# Access Compliance Report

## Public Rights-of-Way

### (Curb Ramps)

Intersection ID: 13787	Main Street: CHARLOTTETOWNE_AV	Cross Street: E_4TH_ST	Location:	S
ADA ID: 3737BD26D940	Ramp Type: PerpDiag	Initial Pass/Fail: Fail	Overall Compliance: No	Severity Score: 12.5
Codes/Mitigation Info/Possible Solution		Field Measurements/Component Compliance

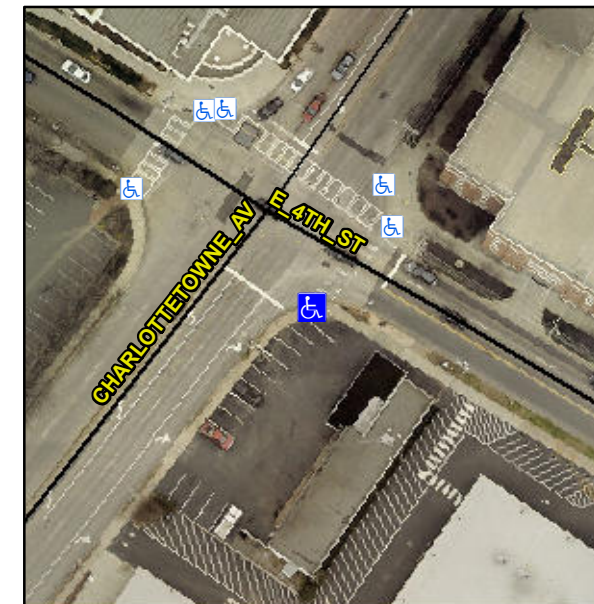
**Not Found, R304.2.2**

Compliance	Description	Data	Compliance	Description	Data
N/A	Ramp Length (in)	76.5	No	Ramp Slope (%)	11.6
Yes	Ramp Width (in)	48.0	Yes	Ramp XSlope (%)	1.1
N/A	Flare Type LT	N/A	N/A	Flare Type RT	N/A
N/A	Flare Slope LT (%)	N/A	N/A	Flare Slope RT (%)	N/A
N/A	Flare Traversable LT?	N/A	N/A	Flare Traversable RT?	N/A
N/A	Landing Length (in)	N/A	N/A	DWS Provided?	N/A
N/A	Landing Width (in)	N/A	N/A	DWS Contrast?	N/A
N/A	Landing Slope (%)	N/A	N/A	DWS Length (in)	N/A
N/A	Landing X Slope (%)	N/A	N/A	DWS Full Width?	N/A
N/A	Landing Curb? (Y/N)	N/A	N/A	DWS Offset (in)	N/A
N/A	Shared Landing?	N/A			
N/A	Gutter Ponding?	N/A	N/A	Gutter Slope (%)	N/A
N/A	Gutter Lip Ht (in)	N/A	N/A	Gutter X Slope (%)	N/A
N/A	Painted X Walk1?	Yes	N/A	Painted X Walk2?	No
	X Walk 1 Direction	To NE		X Walk 2 Direction	To NW
N/A	X Walk 1 Width (in)	106.0	N/A	X Walk 2 Width (in)	N/A
	X Walk 1 Slope (%)	1.2		X Walk 2 Slope (%)	1.1
	X Walk 1 X Slope (%)	0.1		X Walk 2 X Slope (%)	1.9

**Remove & Replace Curb Ramp With Two New Directional Ramps or Equivalent.**
